**AGENDA ITEM: IIB**

HPO File No. 070602

**SITE NAME:** Fire Station # 11**SITE LOCATION:** 4520 Washington Avenue**Owner:** ANT Holdings LLC**Applicant:** ANT Holdings LLC

**TYPE OF APPROVAL REQUESTED:** The building on the site is a City of Houston Protected Landmark (06PL18) and therefore is not subject to the 90 day waiver provision. The applicant requests a certificate of appropriateness for the following work:

**Site Plan – (Showing Proposed Construction of Rear Addition & Stairs)**  
Not to scale

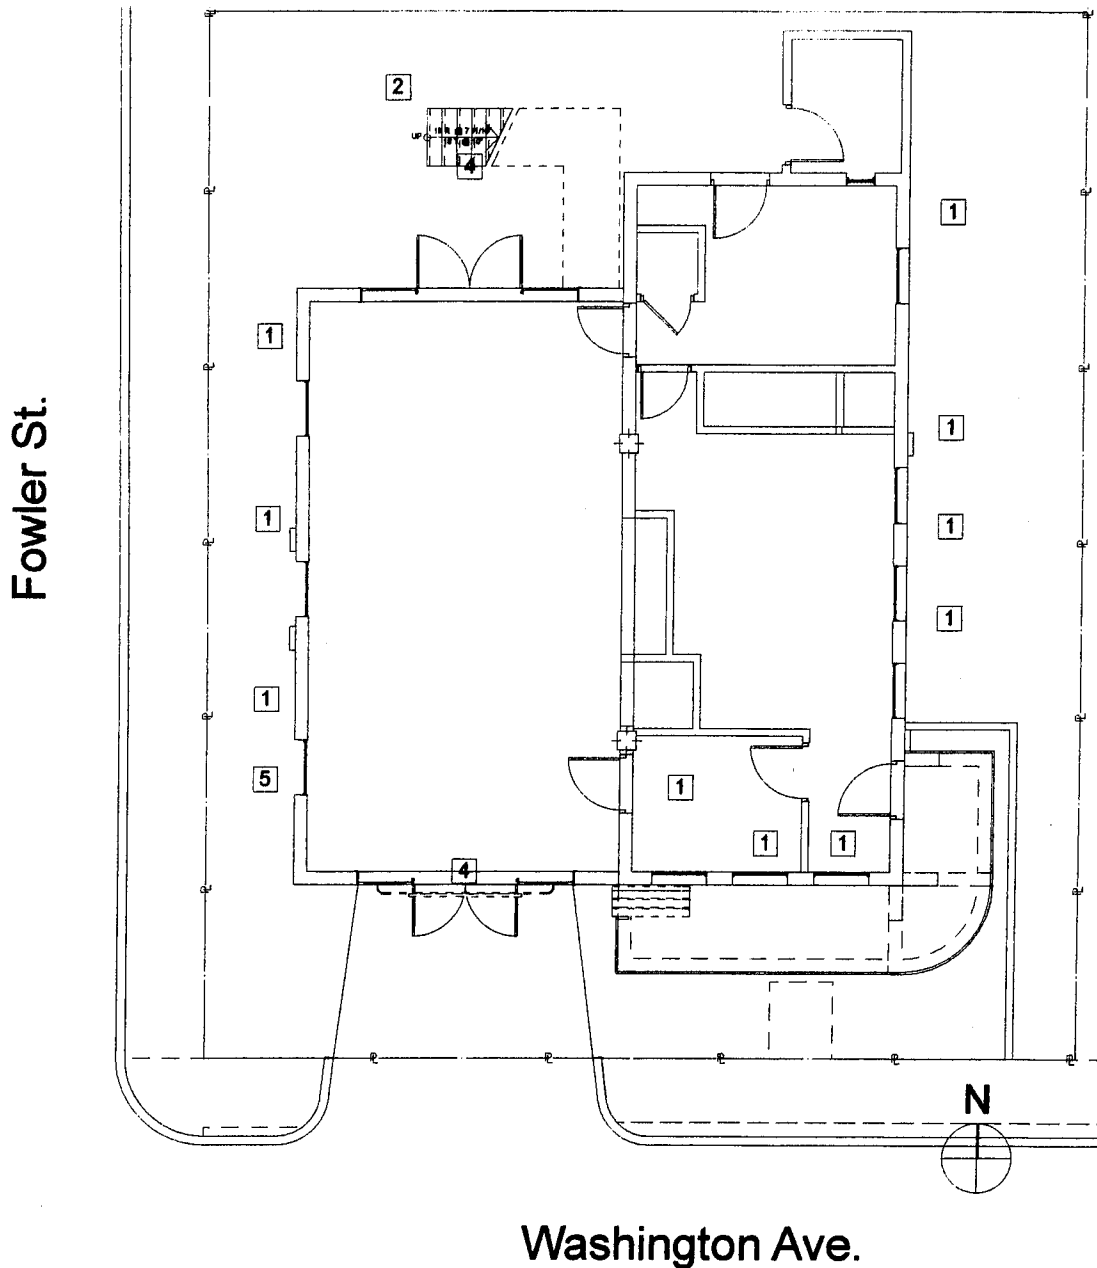
- North Elevation; the north elevation will maintain all existing door locations. In the existing roll up door location at the rear of the engine bay, remove an existing garage type roll up door, which is a modern replacement; In its place install a pair of multi-light, metal framed doors with matching transom and sidelights. Composite appearance of paired doors and transom and sidelights will mimic the look of a roll up bay door. Construct a one-story storage room and exterior stairs to the rear (north side) of the building which will be also be visible from Fowler Street. The one story storage room will be placed to the northeast corner of the rear of the building and will not be visible from Washington Avenue. The storage room will be stucco clad and will be free of ornamentation and will feature one metal door which will face west towards Fowler Street. Metal stairs will be open air and will feature metal railing and balustrade.

**STAFF RECOMMENDATION:** Approval of the certificate of appropriateness as requested by the applicant.

**South Elevation - (Front of Building Facing Washington Ave.)**  
**Not to scale**

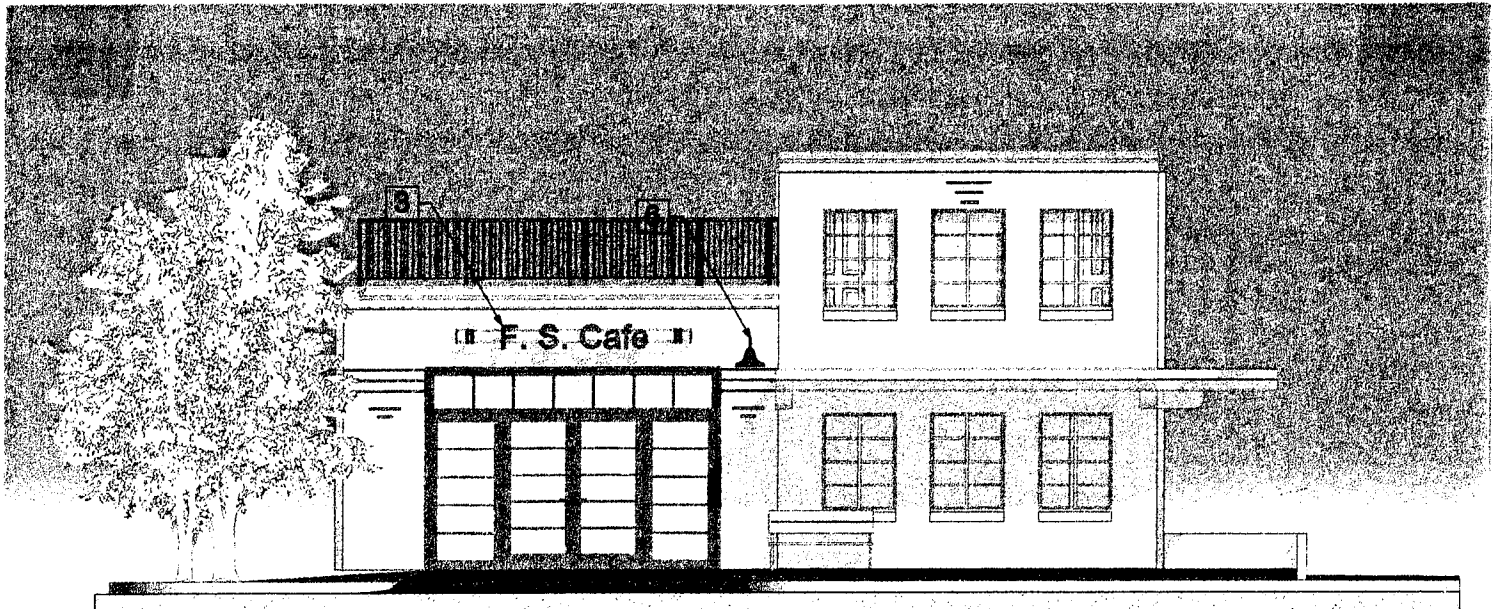
- South Elevation: Restore all exterior features of the Art Deco fire station building as original on the South (primary) elevation which faces Washington Avenue. Restoration plans call for the retention/restoration of all exterior architectural elements of the building. All exterior door and window opening locations to remain unchanged. Existing steel casement windows will be repaired or replaced in kind. All stucco exterior finishes will be restored and repainted. Existing brushed aluminum canopy will be restored and remain in place. The green enameled light fixture located between the rollup bay door and the front awning, which is an original feature of the building, will be restored and remain in this location. Install new multi-light, metal clad doors in original roll up engine bay door location. The existing roll up type garage door, currently located in the engine bay door location is a modern replacement which is in very poor condition. Engine Bay door location will feature a pair of multi-light metal framed doors with matching transom and sidelights. Composite appearance of paired doors and transom and sidelights will mimic the look of a roll up bay door and which will allow additional light into the retail/restaurant space; Install a sign in the same location and in the same style as the original Fire Station #11 sign which was originally affixed above the roll up bay door facing Washington Avenue, but which is no longer present on the building.

**West Elevation - (Facing Fowler Street)**  
**Not to scale**

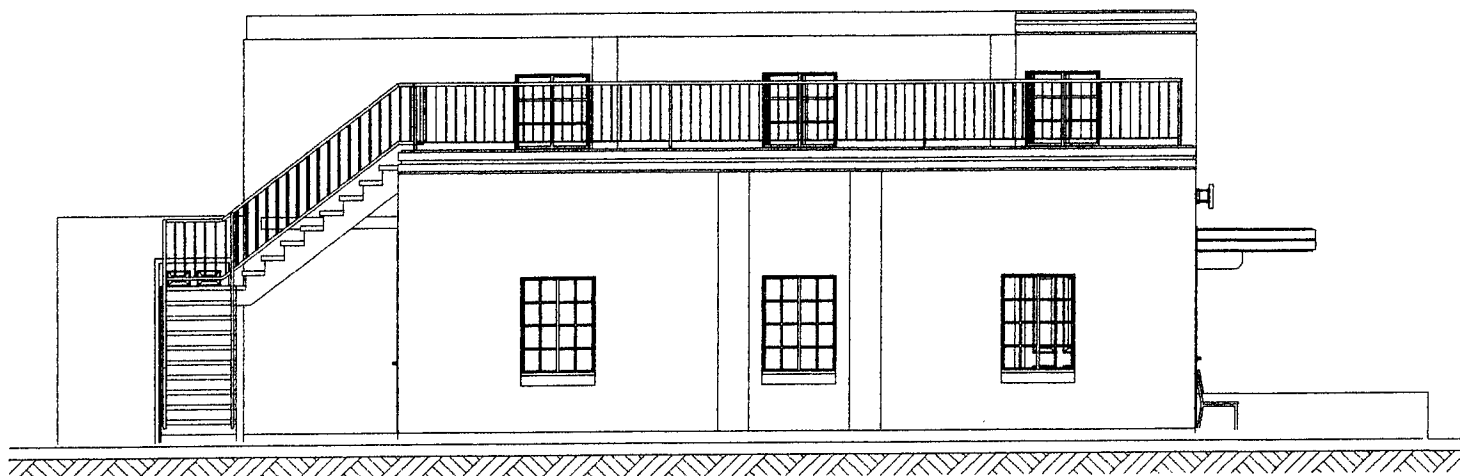
- West Elevation (which is visible from Fowler Street): Restore all original exterior elements. Original window locations will remain unchanged and existing steel casement windows will be repaired or replaced in kind.

**East Elevation  
Not to Scale**

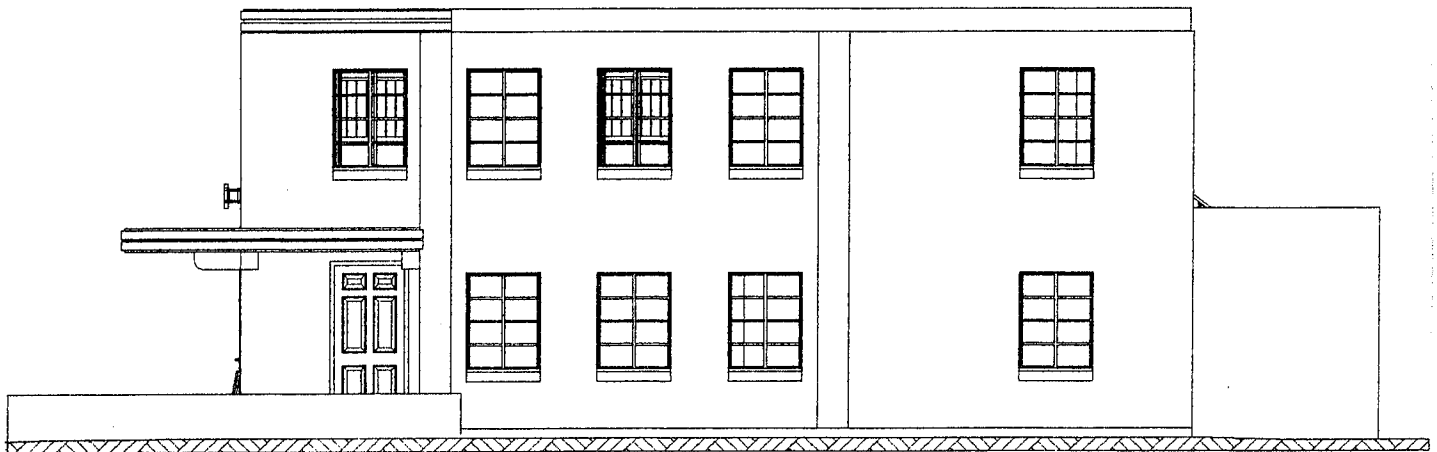
- East Elevation; Restore all exterior features. Paired steel frame casement windows will be restored or replaced in kind. Install a smooth steel or wood slab door in original location which is located on the side of the building near Washington Avenue.
